Technical Appendices - Volume III
(Response to Comments)

Draft Environmental Impact Report

Sycamore Landfill Master Plan

Project No. 5617
SCH No. 2003041057

Additional Information for ASN 2004-AWP-4044-OR

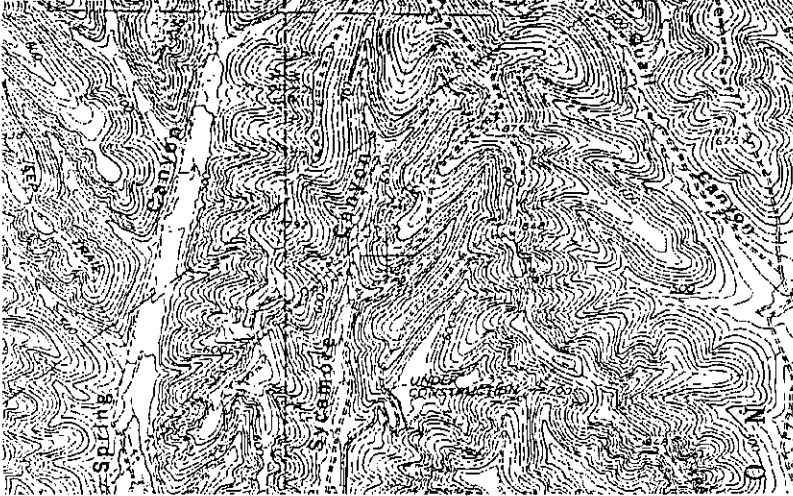
THE COORDINATES SUBMITTED BY THE SPONSOR CALCULATE THIS LANDFILL TO BE SITED 3.63 NAUTICAL MILES (NM) FROM THE GILLESPIE FIELD (SEE) AIRPORT REFERENCE POINT, THE CLOSEST PUBLIC-USE LANDING AREA.

THE LANDFILL, AT THE PROPOSED HEIGHT, IS IDENTIFIED AS AN OBSTRUCTION BY EXCEEDING THE STANDARDS OF FEDERAL AVIATION REGULATION (FAR), PART 77, SUBPART C, AS FOLLOWS: 77.23(a)(2), BY 14 FEET, A HEIGHT MORE THAN 263 FEET ABOVE GROUND LEVEL (AGL), AT THE SITE, WITHIN 3.63 NM OF THE (SEE) AIRPORT REFERENCE POINT.

MAXIMUM ACCEPTABLE HEIGHT OF THE LANDFILL EXPANSION CANNOT EXCEED 263'AGL/1146'AMSL.

The Federal Aviation Administration (FAA) notification referenced in the comment reviewed the Original 1,150 feet Above Mean Sea Level (AMSL) Alternative. It stated that if the Project were above 1,146 feet AMSL, it would be presumed to be a hazard, unless evidence demonstrating that it was not a hazard was submitted that overcame that presumption. The applicant chose not to submit such evidence because, based on discussions with the City of Santee, the applicant already had decided to lower the landfill height to 1,050 feet AMSL, in order to minimize visual quality impacts. On March 25, 2008, the Project was submitted to the FAA for review because the original determination (2004-AWP-4004) had expired. The two peaks were assigned case numbers 2008-AWP-1968 and 2008-AWP-1969. The FAA issued Determinations of No Hazard to Air Navigation, Aeronautical Study Nos. 2008-AWP-1968-OE and 2008-AWP-1969-OE, on September 10, 2008, after a circularization process. Previously, on March 25, 2008, the FAA issued Determinations of No Hazard to Air Navigation, Aeronautical Study No. 2008-AWP-1632-OE, 2008-AWP-1633-OE, 2008-AWP-1634-OE, 2008-AWP-1635-OE, 2008-AWP-1636-OE, 2008-AWP-1637-OE, 2008-AWP-1638-OE, 2008-AWP-1639-OE, 2008-AWP-1640-OE, 2008-AWP-1641-OE, 2008-AWP-1642-OE, 2008-AWP-1643-OE, 2008-AWP-1644-OE, 2008-AWP-1645-OE, 2008-AWP-1646-OE, 2008-AWP-1647-OE, 2008-AWP-1648-OE, 2008-AWP-1649-OE, 2008-AWP-1650-OE, 2008-AWP-1651-OE, and 2008-AWP-1652-OE for the landfill boundary points. The FAA issued Determinations of No Hazard to Air Navigation, Aeronautical Study Nos. 2006-AWP-6861-OE; 2006-AWP-6862-OE; 2006-AWP-6863-OE; 2006-AWP-6864-OE; 2006-AWP-6865-OE; 2006-AWP-6866-OE; 2006-AWP-6867-OE; 2006-AWP-6868-OE; 2006-AWP-6869-OE; and 2006-AWP-6870-OE for the transmission line relocation (December 11, 2006) and extensions of those determinations on July 9, 2008. The Airport Authority is scheduled to make a consistency determination on the Project in October, prior to City Council action on the Project.

The Project was submitted for review to the FAA via the Part 77 Notice of Proposed Construction or Alteration (Form 7460-1). The Project was submitted with a maximum height of 1,146 feet AMSL to be conservative, since Alternative 8.8 proposes up to a height of 1,145 feet AMSL, even though the Project has a maximum height of 1,050 feet AMSL. See Response to Comment F1-2 regarding the FAA's issuance of Determinations of No Hazard to Air Navigation.
